ADDENDUM NO. 3

RED CLAY CONSOLIDATED SCHOOL DISTRICT
WILMINGTON CAMPUS RENOVATIONS
BID PACKAGE 'B'

Addendum No. 3 – Consists of the following:

A-704

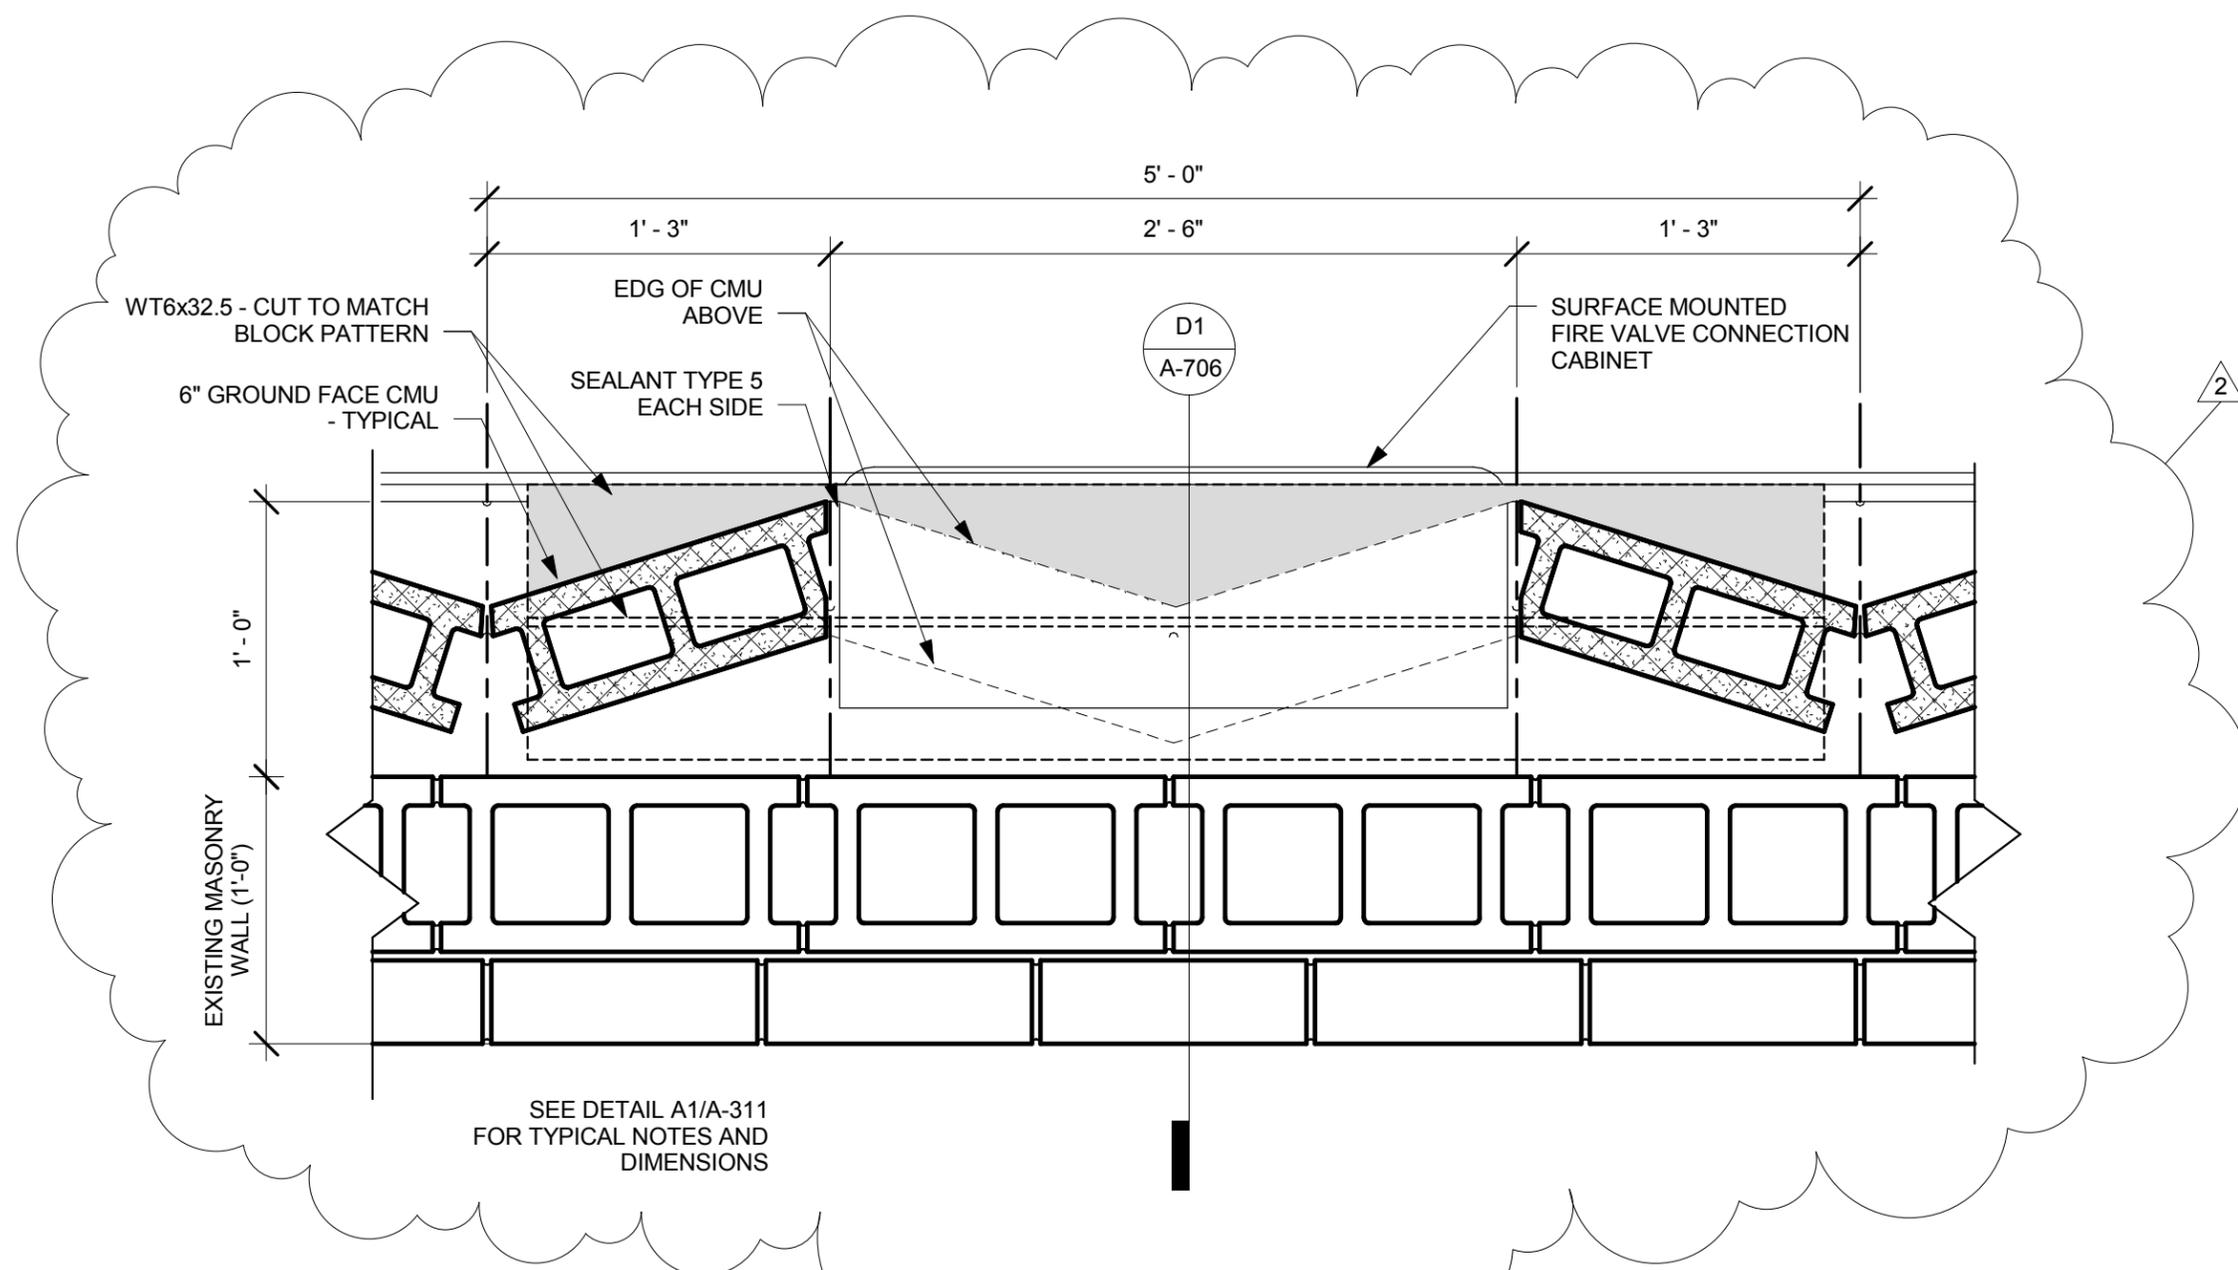
1. REPLACE Detail E6 with revised detail shown on sketch A-704.

Paint and provide base along patched wall for alternate 1, otherwise no work.
See attached sketch A-704

* REPLACE DETAIL E6 ON SHEET I-111

C1 FIRE VALVE CONNECTION PLAN DETAIL
 1 1/2" = 1'-0"
 *ADD TO SHEET A-503

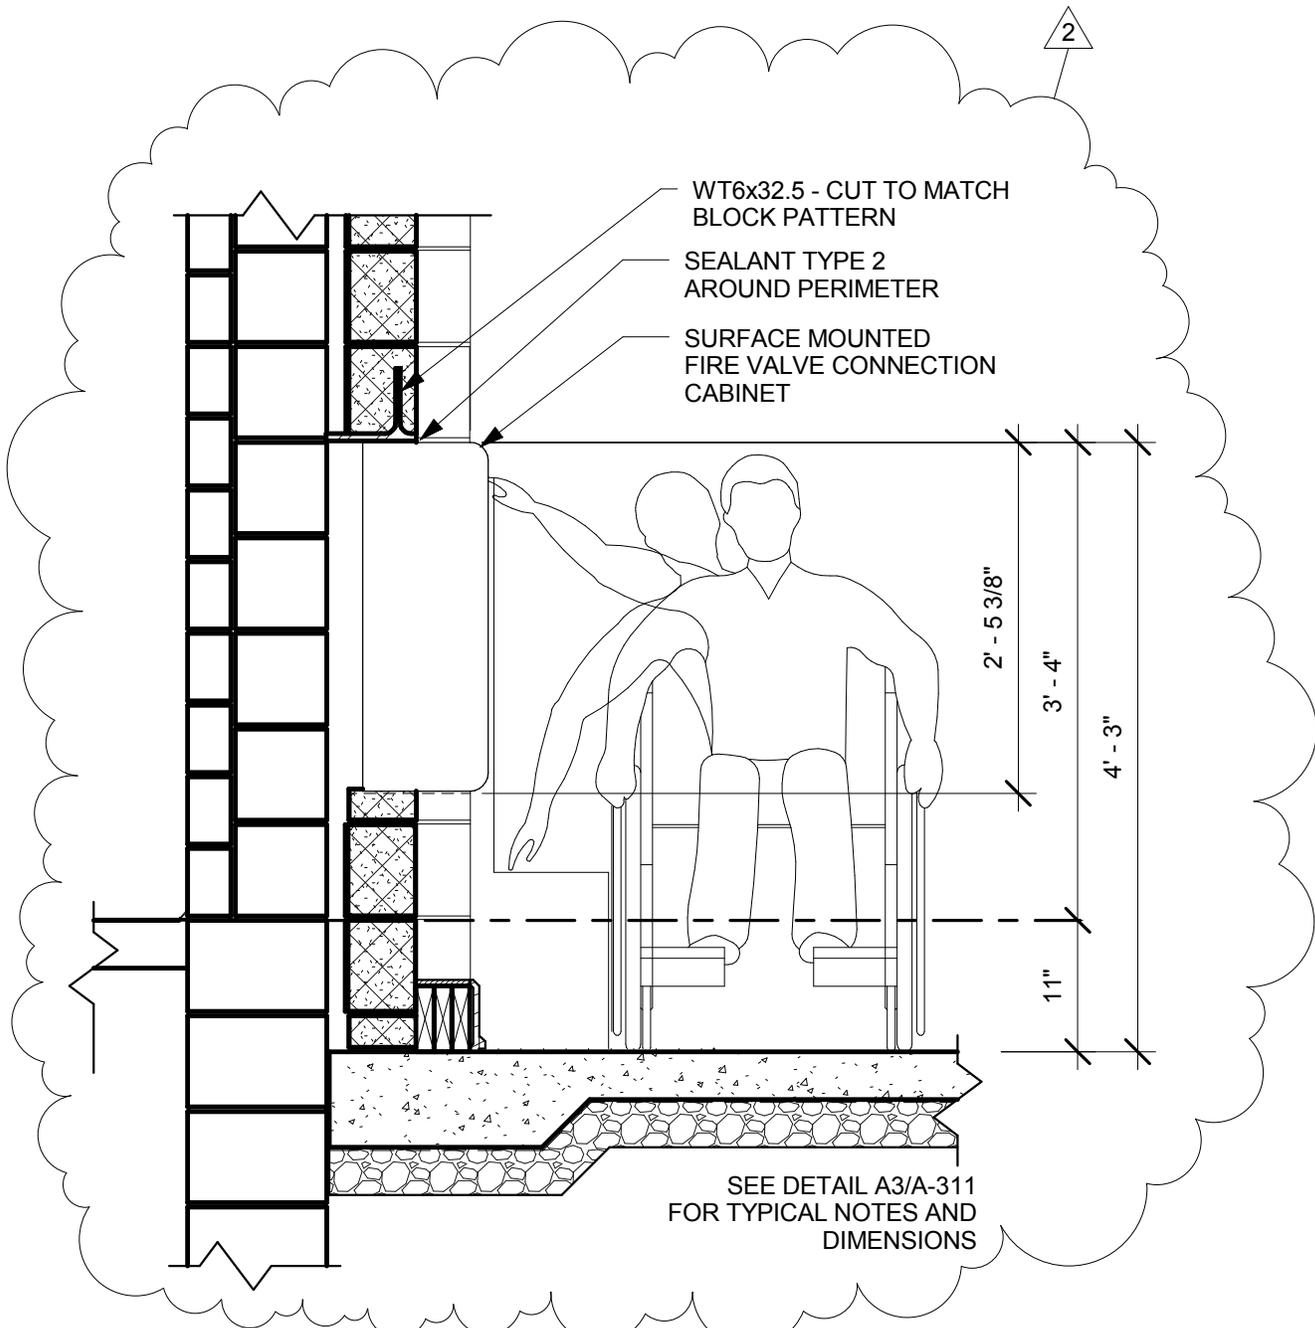
1. Add Detail C1 – See attached sketch A-705
2. Add Detail D1 – See attached sketch A-706

* ADD REVISION TO DETAIL A1/A-102

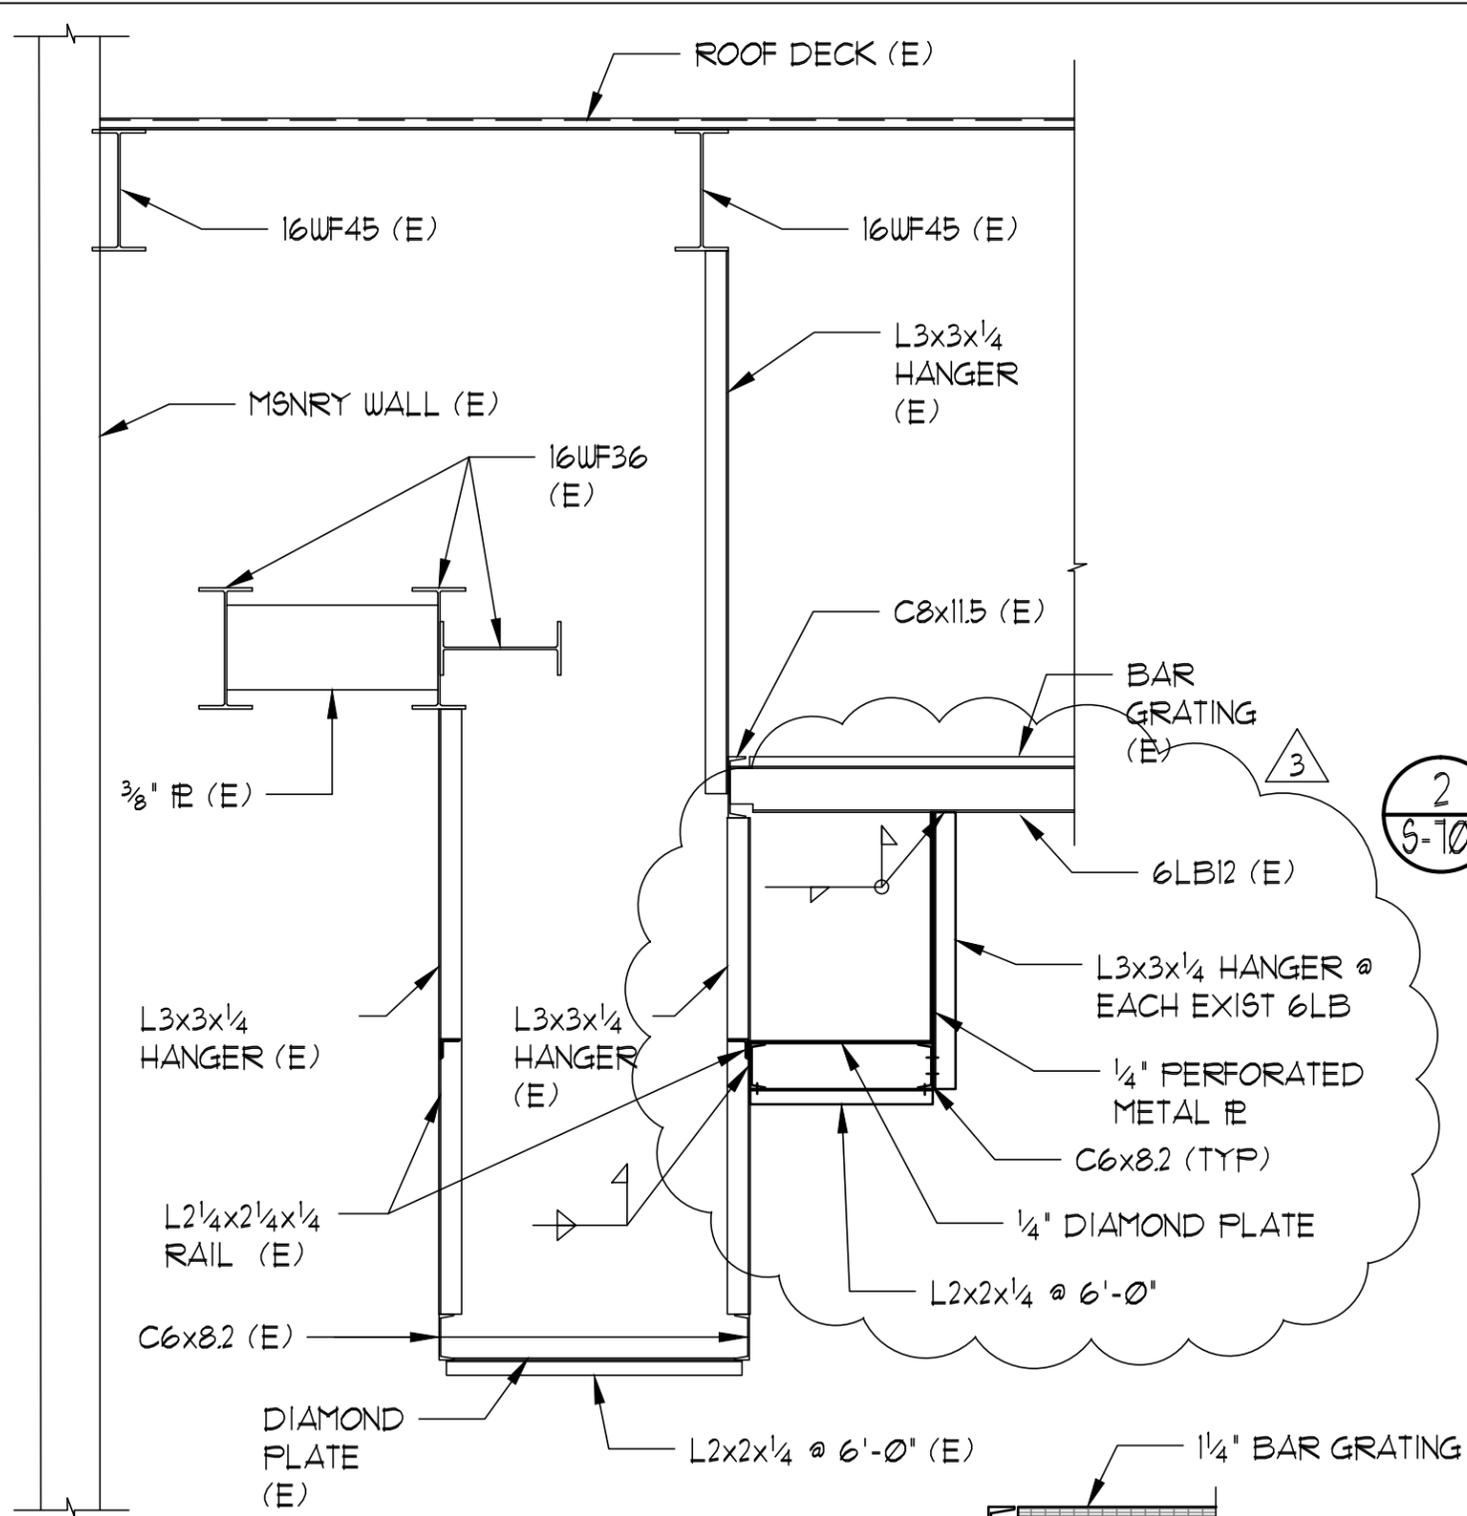
B. A-102 MEZZANINE DEMOLITION PLAN:

1. Add plan A1 shown on sketch A-707.

SHEET TITLE GRID-IRON PLAN & SECTIONS	
PROJECT WILMINGTON CAMPUS RENOVATIONS	
CONSULTANT LARSEN & LANDIS	S-705

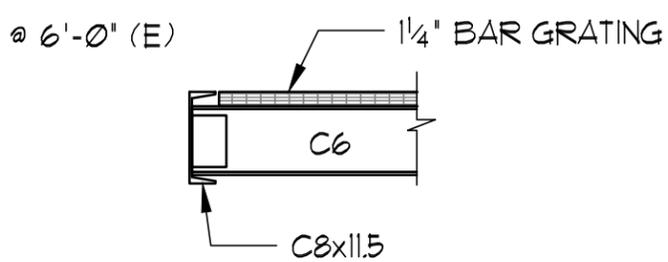
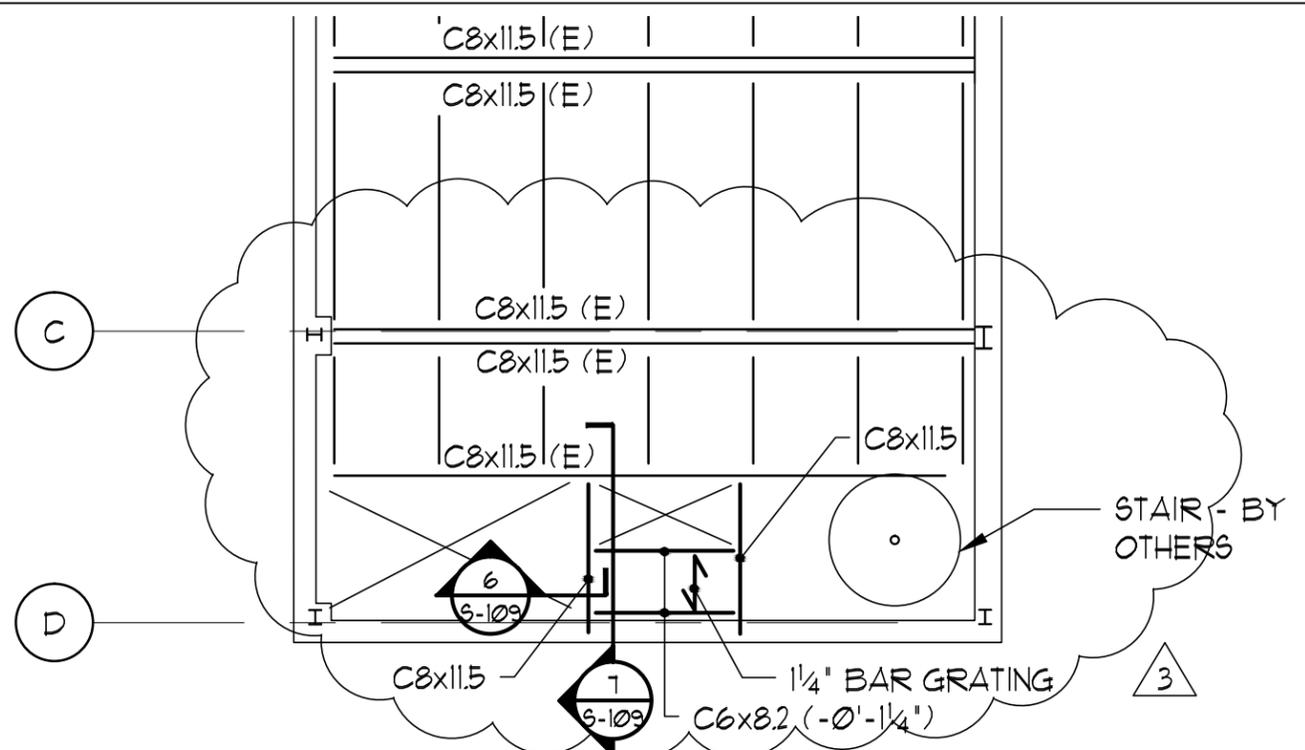
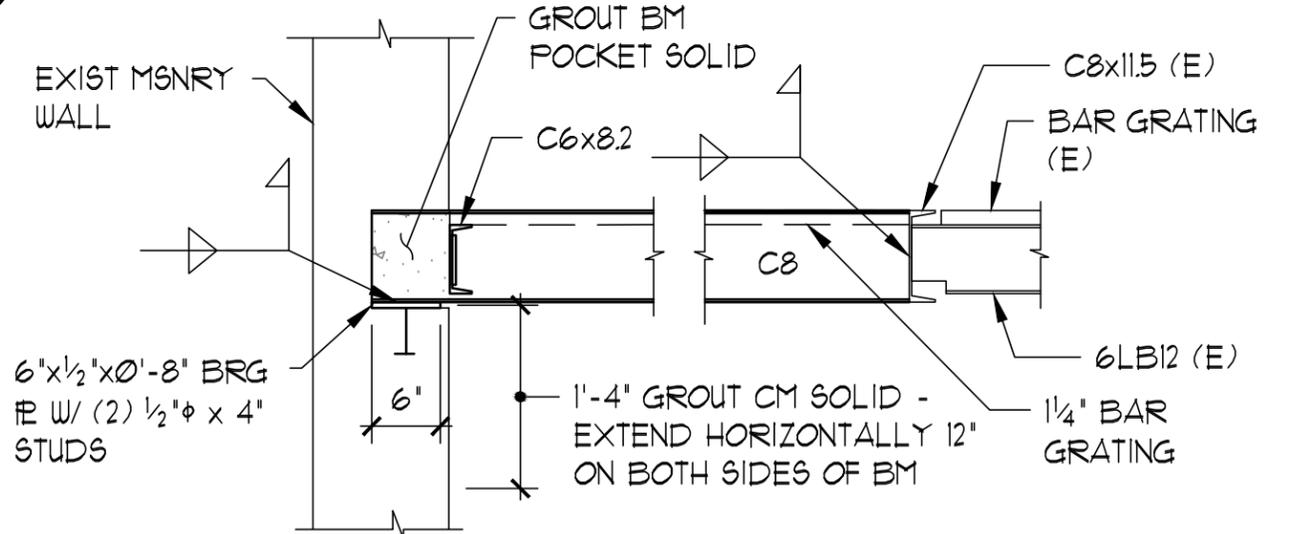
1. MODIFY Detail 2 on S-104 with Detail 2 on Sketch S-705 attached.

1. ADD Details 3 & 4 on Sketch S-705 attached.

9. Dwg A-507 **Details A3, A5 & D5 show ¼" Perforated Metal (see Struct)**
I find no information on perforated metal on the Struct Dwgs
Can a Specification for this be provided?
The drawing details are very vague.
Can additional details be provided?
[Structural detail updated per drawing S-705 \(addendum 3\)](#)

M-709

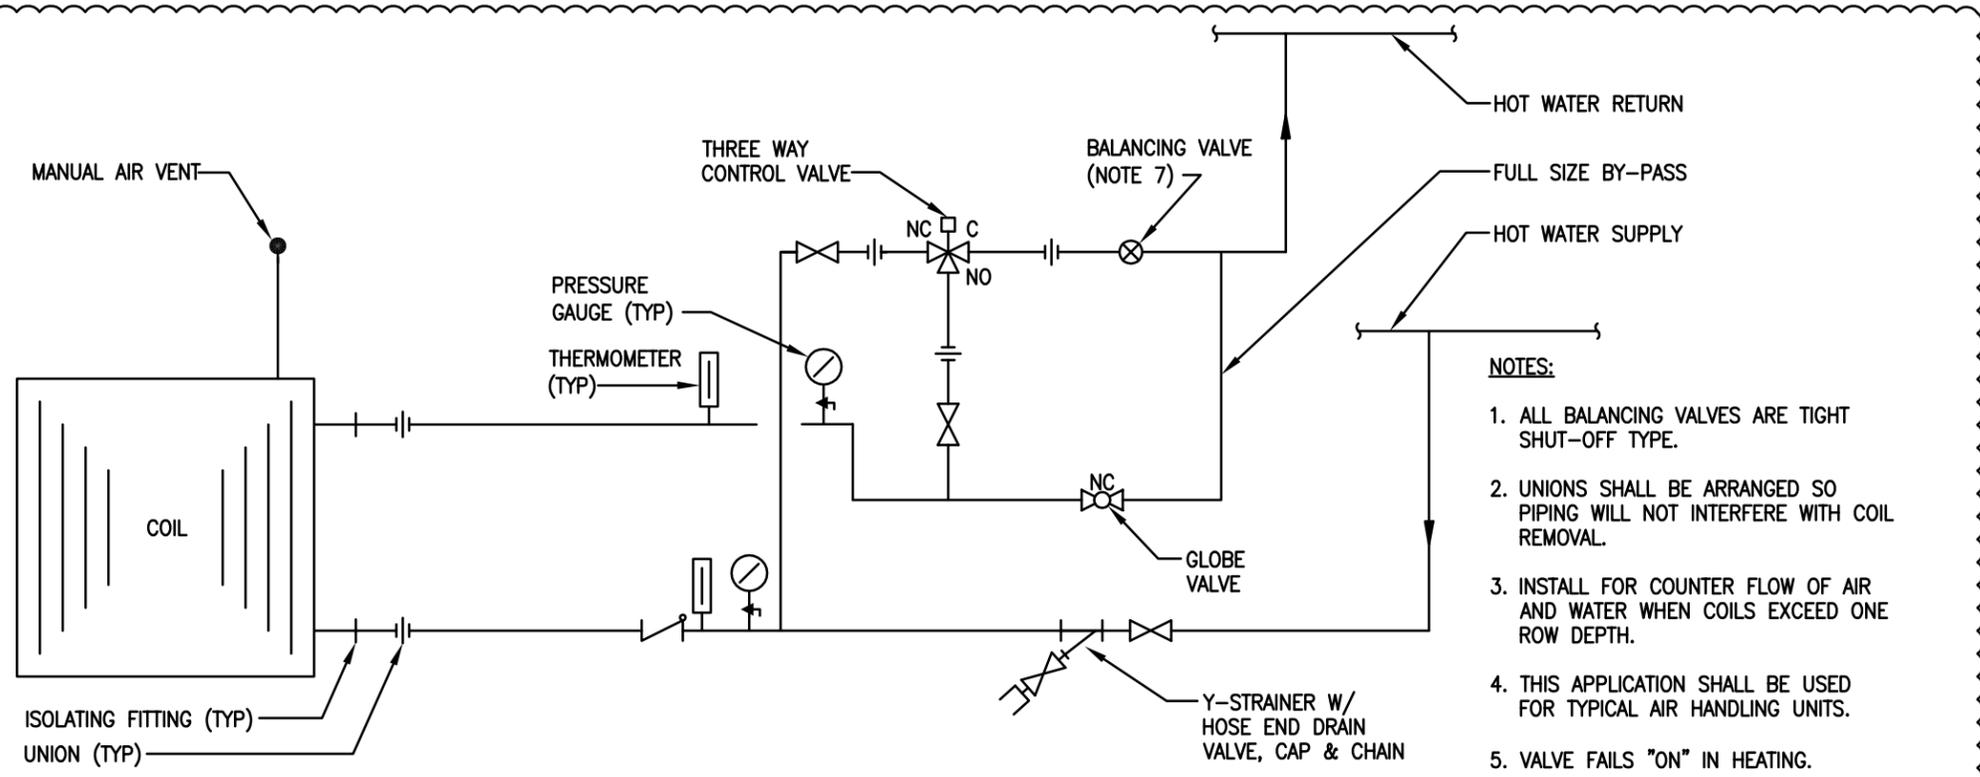
1. Add details. Refer to attached Sketch #M-709 & M-710.
